CHERYL MANN SUBDIVISION, PHASE 1 & 2

APPLICATION NUMBER 14 DATE July 24, 2003

REQUEST Subdivision

CHERYL MANN SUBDIVISION, PHASE 1 & 2

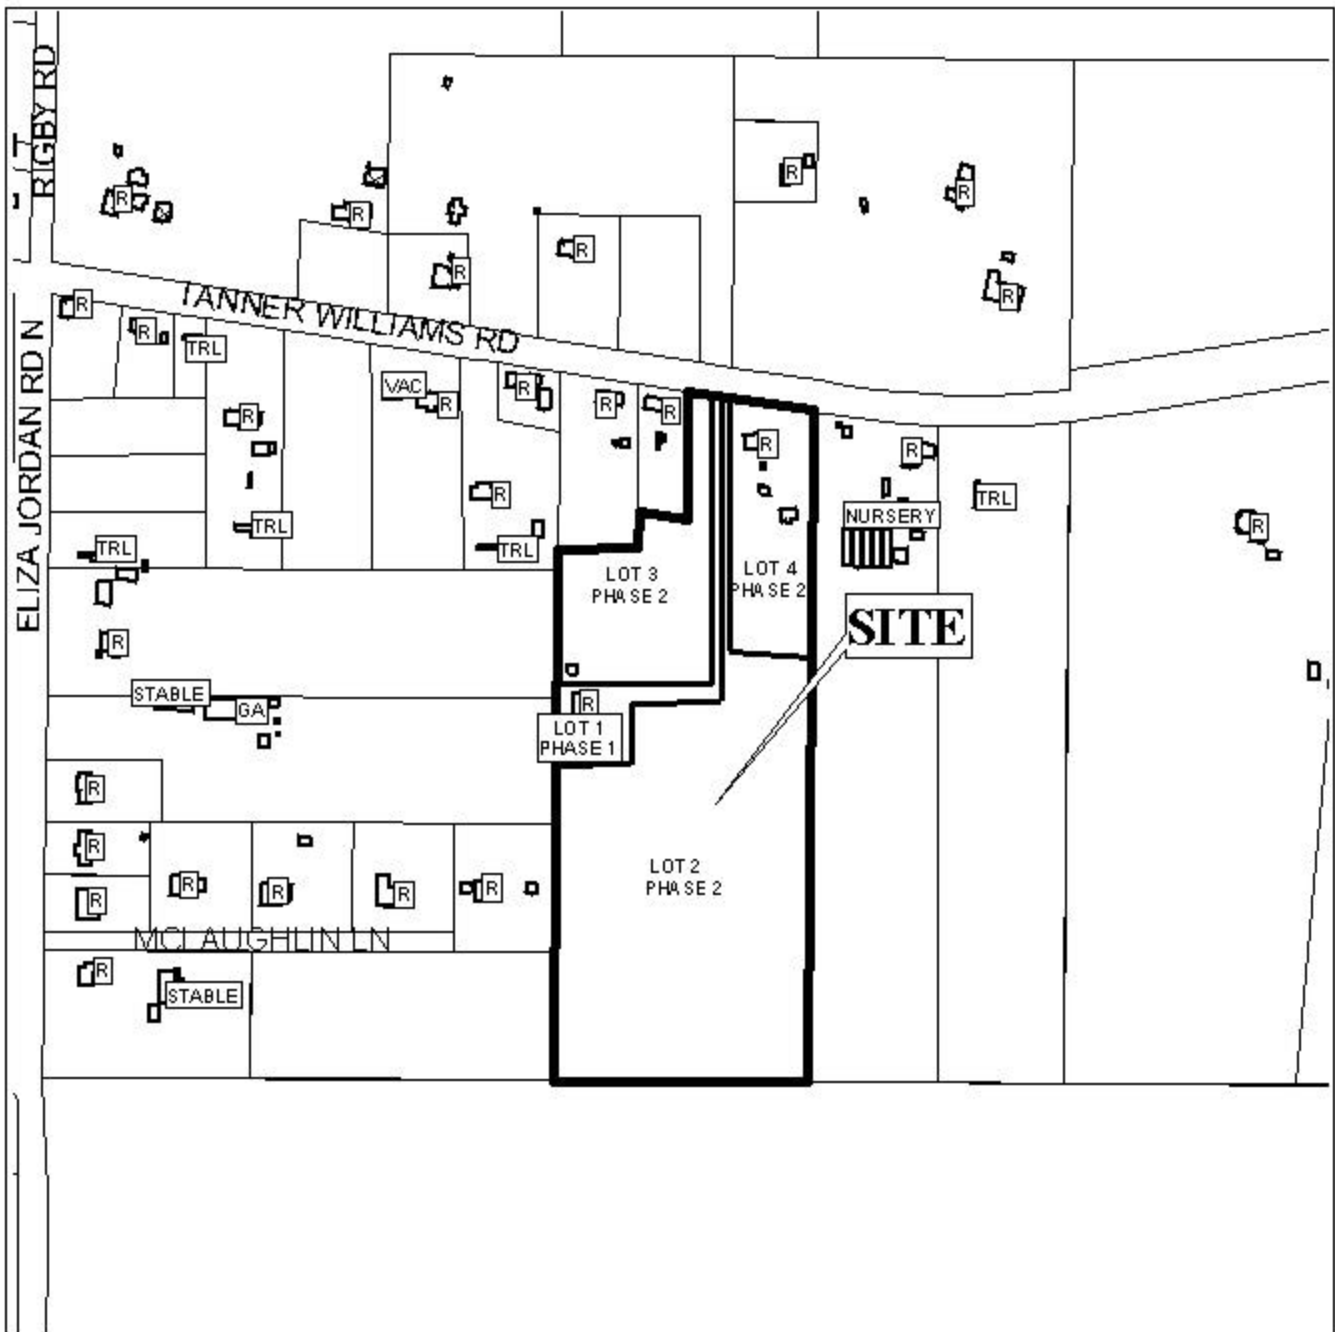
The site fronts Tanner Williams Road, a planned major street, and the existing right-of-way is shown as 60-feet. The Major Street Plan requires a 100-foot right-of-way; therefore, the dedication of adequate right-of-way to provide 50-feet from the centerline of Tanner Williams Road should be required.

As the site is located on a major street, the placement of a note on the final plat stating that Lots 3 and 4 are limited to one curb cut each with the size, location, and design to be approved by County Engineering. Additionally, as Lots 1 and 2 have only 25-feet of street frontage, these lots should be required to share one common curb cut to Tanner Williams Road.

Finally, a note should be placed on the final plat stating that Lots 1 and 2 are denied any future resubdivision, since there is not enough frontages on these Lots.

The twenty-five foot minimum building setback lines are not shown but would be required on the final plat.

This site is located in the County, thus a note should be placed on the final plat stating that any lots which are developed commercially and adjoin residentially developed property must provide a buffer, in compliance with Section V.A.7. of the Subdivision Regulations.

The plat meets the minimum requirements of the Subdivision Regulations and is recommended for Tentative Approval subject to the following conditions: 1) the dedication of sufficient right-of-way to provide 50-feet from the centerline of Tanner Williams Road, a planned major street; 2) placement of a note on the final plat stating that Lots 3 and 4 are limited to one curb cut each to Tanner Williams Road; 3) placement of a note on the final plat stating that Lots 1 and 2 are required to share one common curb cut to Tanner Williams Road; 4) placement of a note on the final plat stating that Lots 1 and 2 are denied any future resubdivision; 5) placement of the 25-foot minimum building setback lines on the final plat; and 6) the placement of a note on the final plat stating that any property that is developed commercially and adjoins residentially developed property shall provide a buffer, in compliance with Section V.A.7. of the Subdivision Regulations.
